SHIRE OF DENMARK Town Planning Scheme No. 3

LOT 366 HORSLEY ROAD DENMARK

LOCAL STRUCTURE PLAN AMENDMENT

Submissions Received from Public – Proposed Amendment to Horsley Rockford Structure Plan – Lot 366 Horsley Road Denmark

BAL Contour Plan

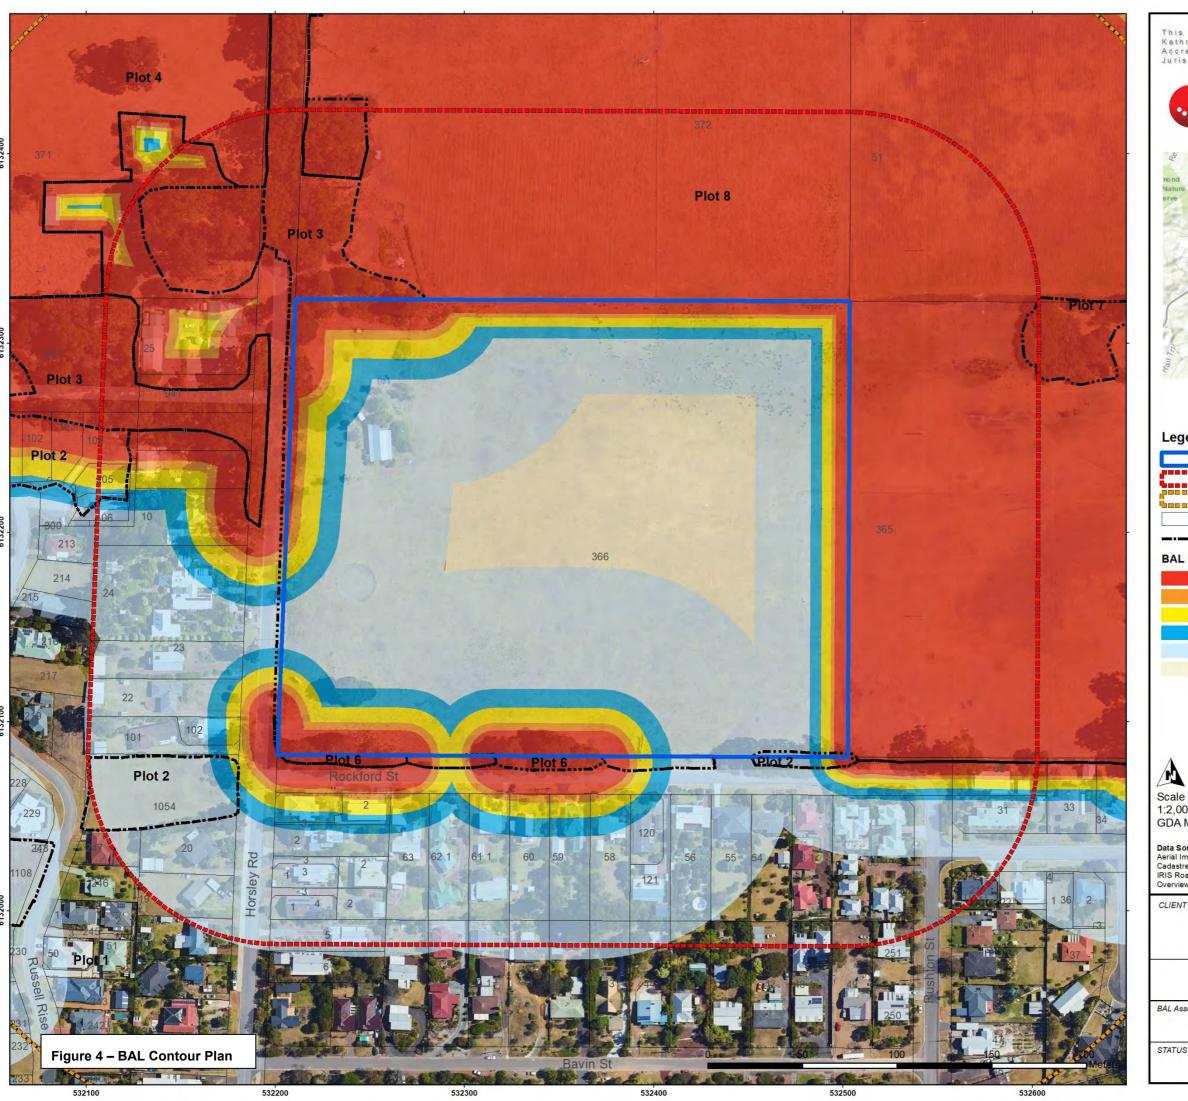
The BMP should detail specifically how the Class B Woodland classification was derived as opposed to ClassA Forest.

If unsubstantiated, the vegetation classification should be revised as per AS3959:2018 or the resultant BAL ratingsmay be inaccurate.

The policy required structure plans and subdivisions to achieve BAL-29 for the entire lot not for the potential future buildings. Lots with a BAL rating of BAL40/FZ should not be supported as per policy measures 6.7.

DFES. The vegetation causing the BAL40/FZ within the structure plan area is outside the lot boundary.

As the vegetation that gives rise to the bushfire threat is located within the adjacent road reserve, this can be modified and kept in a low fuel state through agreement with the Shire under the 'Activities on Thoroughfares Local Law.

Amaroo Care Services Inc preliminary concept design options

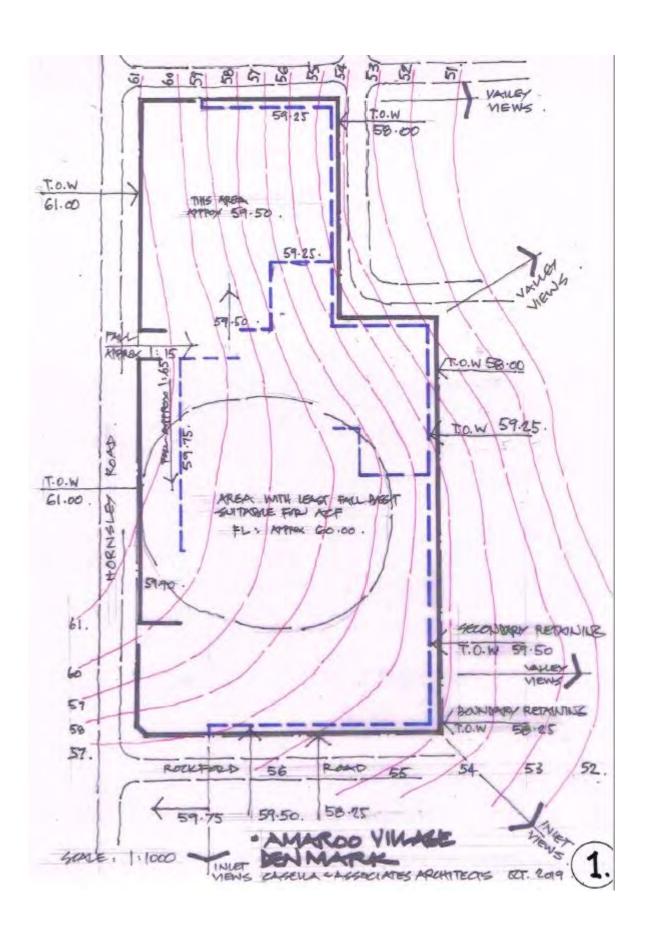
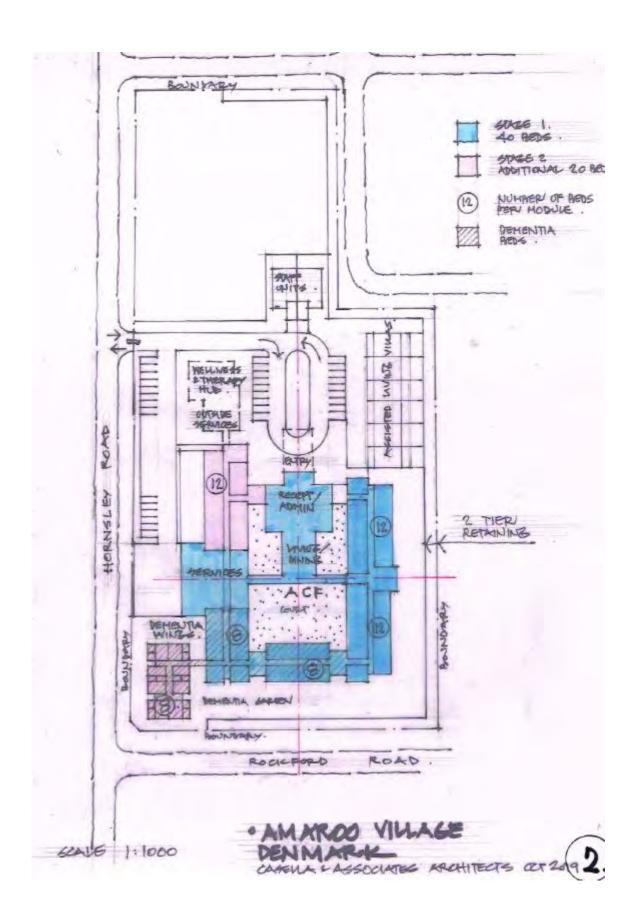
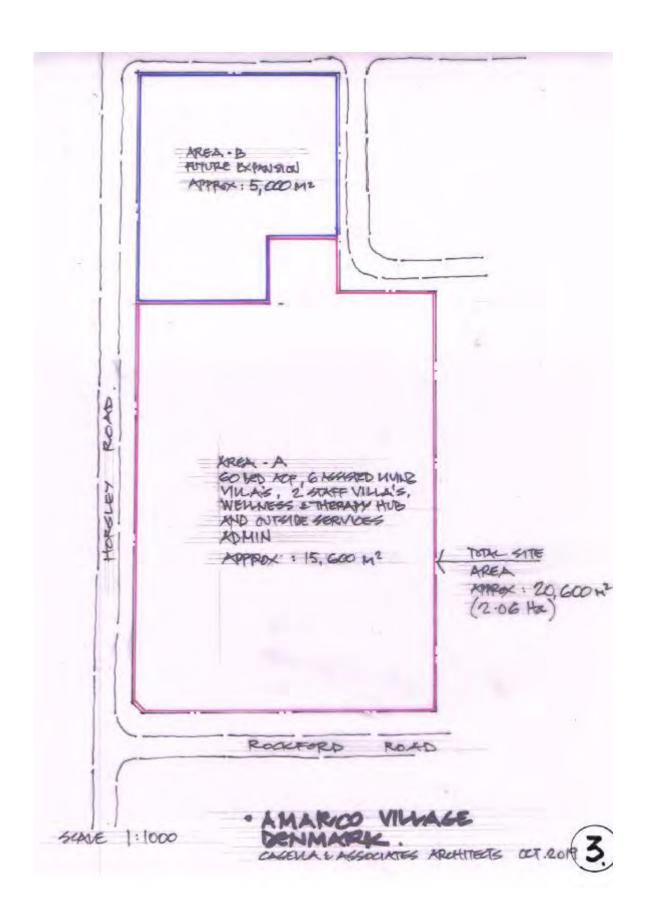
- 4. As outlined in the SPN amendment report, a considerable amount of fill will be required along the Rockford Street frontage to achieve a level site to accommodate the Retirement and Aged Care development. The concept plans show retaining wall heights ranging from 1.25m above natural ground level (NGL) up to 4.5m above NGL (figure 2). These retaining walls will be either on or within close proximity to the Rockford Street frontage.

Whilst an <u>indicative</u> plan for the future development of the Aged Care Facility was included with the bushfire assessment, this does not form part of the Amendment Structure Plan proposal.

The applicant has confirmed that the indicative development plan provided with the BMP is not reflective of current thinking and was prepared to inform a preliminary bushfire and some due diligence works.

Submission Attachment - S2

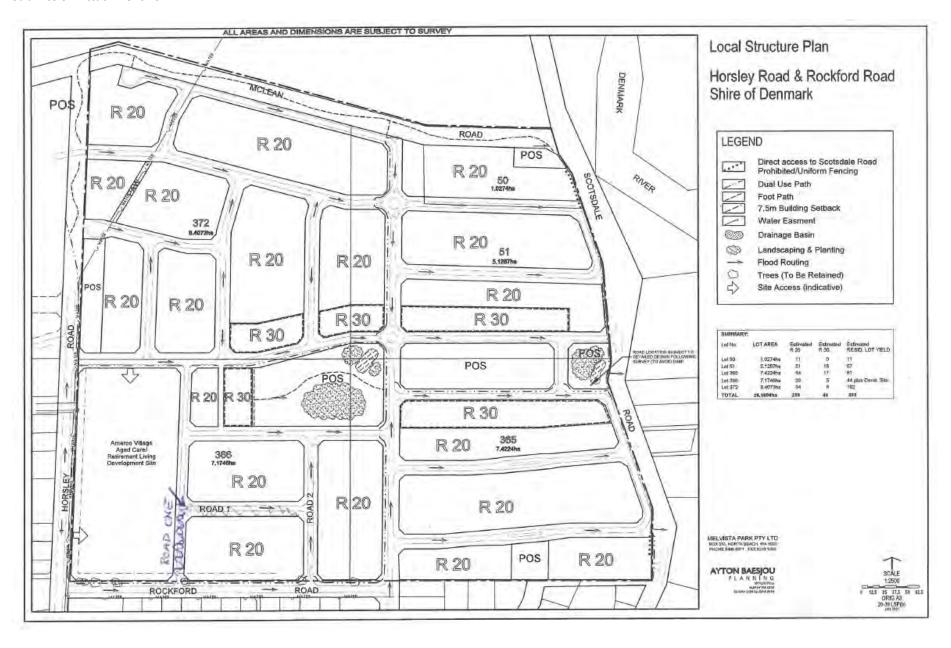
Existing Structure Plan identifies Lot 366 as ceding a total of 10.5% of the land area, no change to this is proposed as part of the amended structure plan.
S2	REDACTED	I am writing in response to the above stated Local Structure amendment plan regarding the development of Lot 366 Horsley Road.	Upheld (in part) Support for aged accommodation noted.
		I am a long standing resident of Rockford street Denmark and consequently have a deep connection to, and investment in both the safety implications for some aspects of the proposed development and the natural environment. I applaud the plan as a dignified response to the aged population in Denmark however I would like make the following points: DRAINAGE:	Drainage The existing structure plan shows that most drainage from future development will be directed back into a centrally located public open space (POS) area with drainage basins. The direction of drainage is shown by arrows in the proposed roads.

It appears that the drainage system for Amaroo Village and the subdivision will be leveraging off the Rockford Street drainage network. This system is at full capacity. It is critical that this point be considered and planned for to include the development of a drainage system to service Amaroo Village and subdivision that is separate to that already in existence for Rockford Street. The Shire engineer and Building Inspector Graham Blackmore are very aware that the drainage for Rockford Street is working at and over capacity with subsequent problems arising for residents in Rockford street and beyond. The residents of Rockford street have always had to deal with this huge drainage problem. E.g.: Number 6 Rockford Street has had to insert two industrial sumps to deal with this deluge running into her property.	The proposed amendment makes no change to the proposal, therefore drainage design from future residential development will be directed away from Rockford Road. The future development of an Aged Care Facility will be a single development application that will need to show how it is dealing with stormwater on site and accommodate overland flow paths in a storm event. Given the topography, little water in a storm event would be directed to Rockford Road. However, it should be acknowledged that in a storm event roads naturally act as the overflow route.
